RESPONSE TO SUBMISSION:

STAGED RESIDENTIAL SUBDIVISION OF ONE EXISTING ALLOTMENT TO CREATE 123 TORRENS TITLE LOTS FOR FUTURE RESIDENTIAL DEVELOPMENT AND 22 RESIDUE LOTS AND ASSOCIATED WORKS INCLUDING BULK EARTHWORKS, CIVIL WORKS, CONSTRUCTION OF TEMPORARY ON-SITE DETENTION BASINS, STORMWATER DRAINAGE AND NEW ROADS AT LOT 184 GURNER AVENUE, AUSTRAL

This technical memorandum is prepared to respond to comment No. 4 provided by TfNSW issued on 27 May 2022 for the abovementioned application:

Figure 1 Proposed intersection layout

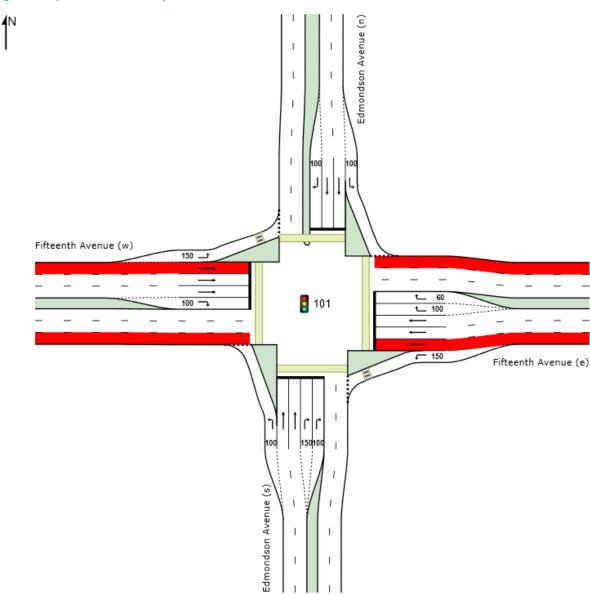
It is unclear as to which intersections have been assessed. TfNSW requires SIDRA modelling to show predicted growth with general practice usually showing modelling for the day of opening plus 10 years post-development. TfNSW requests the intersection of Edmondson Avenue and Fifteenth Avenue to be assessed in the SIDRA modelling. SIDRA outputs shall be submitted for further review.

It is noted that the intersection of Edmondson and Avenue Fifteenth Avenue is expected to be upgraded to a fully signalised intersection to accommodate the traffic increase in the future. The proposed geometry is based on the layouts specified in the *Austral and Leppington North Precinct Plan – Post Exhibition Planning Report* (Addendum) 2012 (**Figure 1**).
